Issued by Canon Europa N.V.

iR4570-008  
(F1-T01-0M4-10018-01)

Introducing a new model (iR2230/3530)

With introduction of the new model iR2230/3530, differences from the existing model iR2270/3570 are informed in this bulletin.

F-1

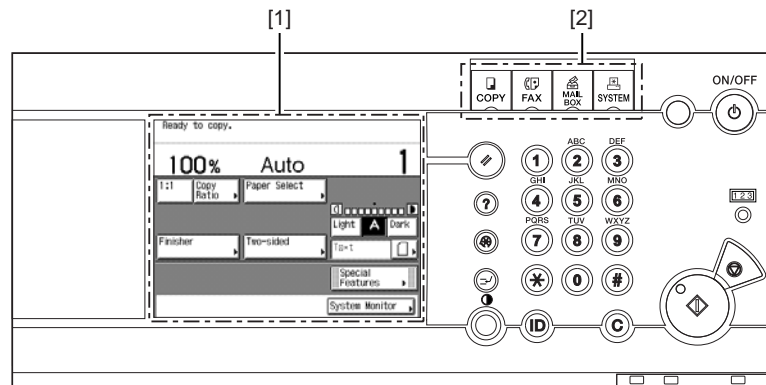
### Change of the control panel unit

- [1] The LCD has become smaller and black-and-white.
- [2] The function keys have become hard keys.

F-2

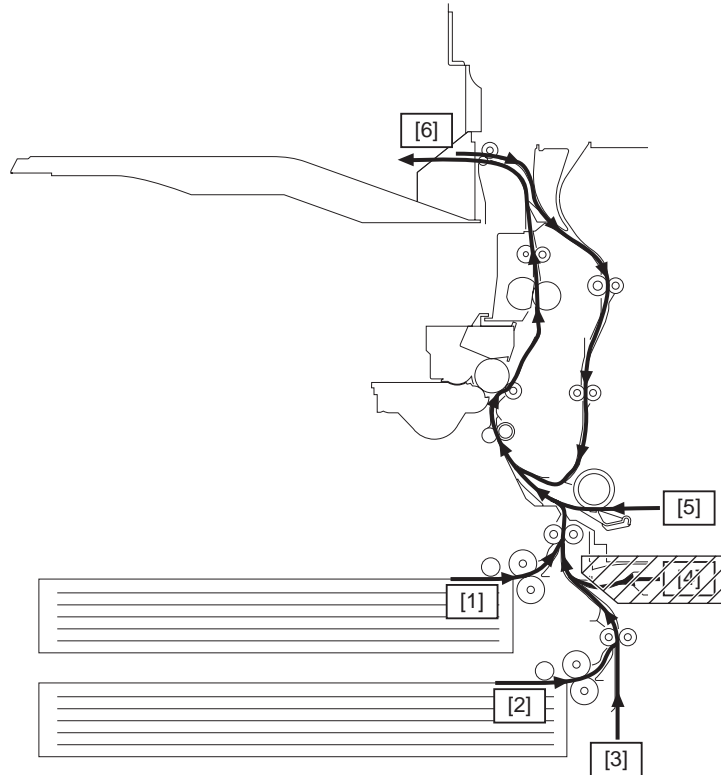
The Paper Deck-Q1 has been deleted from options. With this change, the paper pickup areas from the paper deck are eliminated from the paper path illustrations.

The eliminated areas are shown below.

- [1] Pickup from the Cassette 1
- [2] Pickup from the Cassette 2
- [3] Pickup from the Cassette Feeding Unit (option)
- [4] Pickup from the Paper Deck (**delete**)
- [5] Pickup from the Manual Tray
- [6] Deliver to the Copy Tray 1

F-3

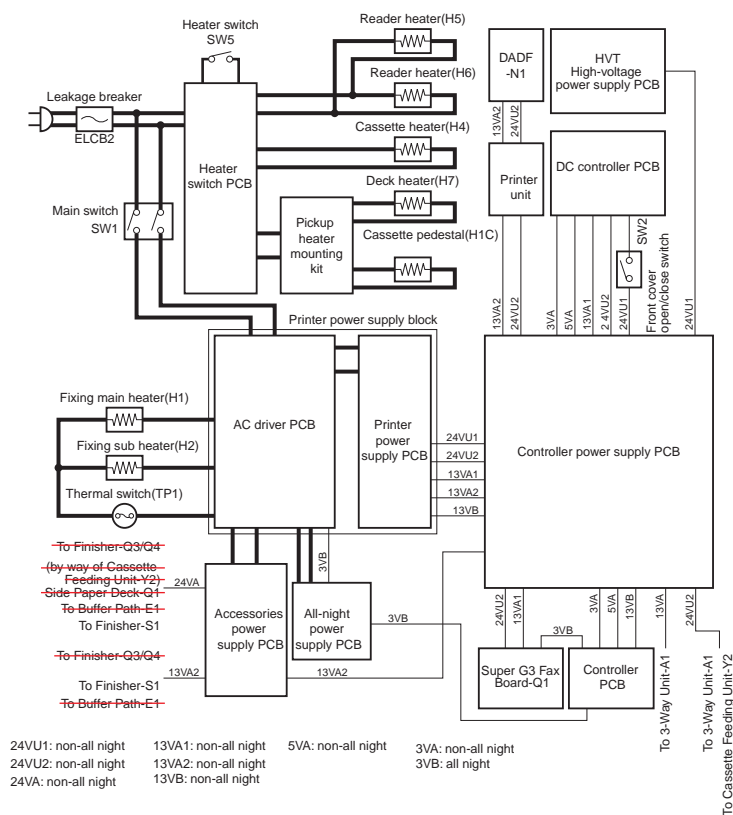
Some pickup/delivery options have been deleted. With this change, the names of options to which power is supplied are eliminated from the power supply illustration on the Service Manual.

F-4

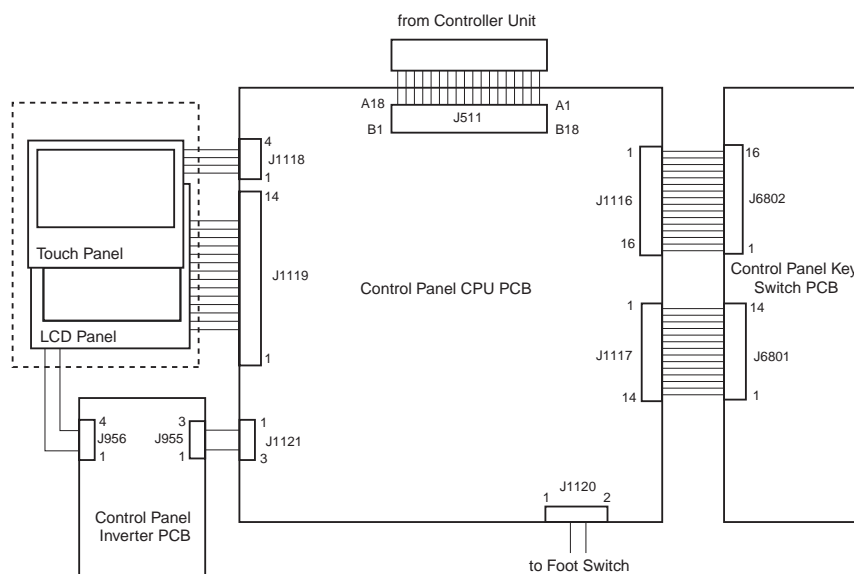
As mentioned above, the LCD has become black-and-white, and the hard keys have been added. Therefore, the board connection in the control panel unit is changed. The changed blocks are shown below.

F-5

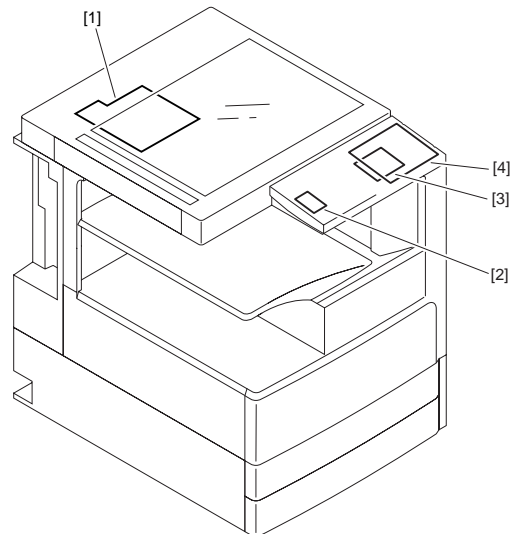
The electrical parts related to the control panel unit are placed as shown below. The parts [2] to [4] are related to the control panel unit.

No.	Name	Part No.	Detail
[1]	Reader Controller PCB	FG3-3765	Control the reader unit/ADF
[2]	Control Panel Inverter PCB	FM2-2753	Control to turn ON the backlight of the LCD
[3]	Control Panel CPU PCB	FM2-2754	Control the control panel unit
[4]	Control Panel Key PCB	FG6-8939	Control numeric keys entry information
